BID ADDENDUM NO. 1

SOUTH PINE STREET WATERLINE, CABY IMPROVEMENTS

Bid Addendum: The Trench Resurfacing detail has been revised to exclude slurry seal. No slurry seal will be required. See attached detail.

TRENCH RESURFACING
CITY OF NEVADA CITY

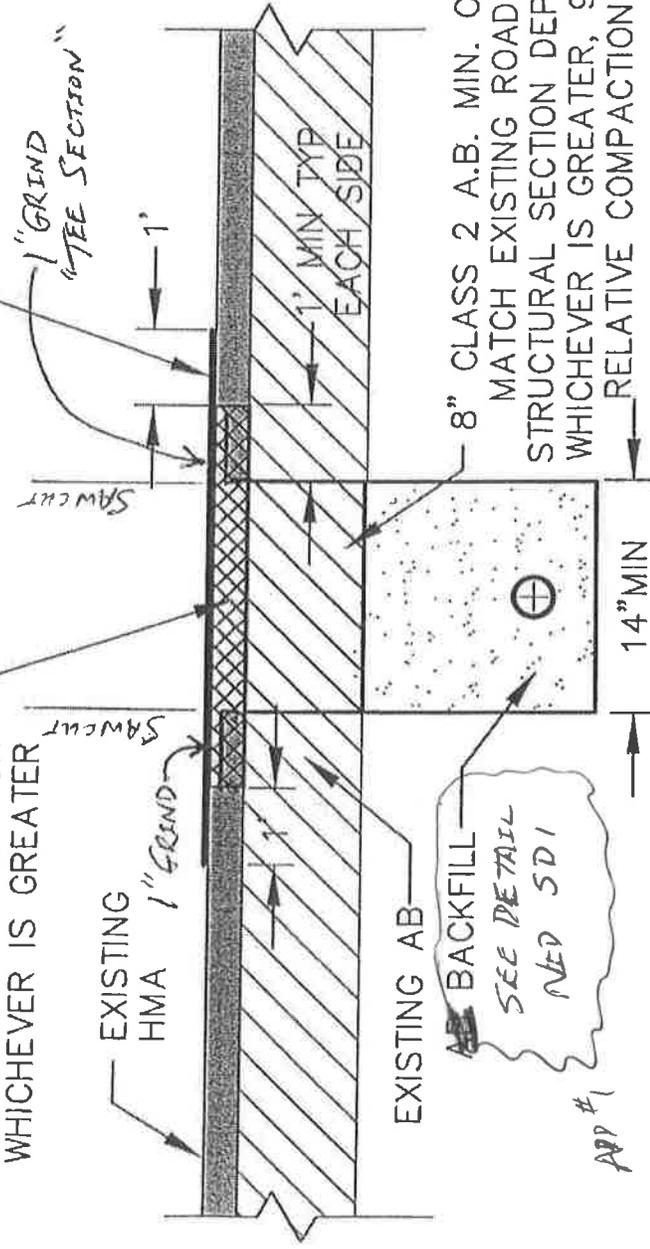
Bid Addendum #1
Slurry Seal not required.

Refer to Detail NID SD1 for bedding and backfill.
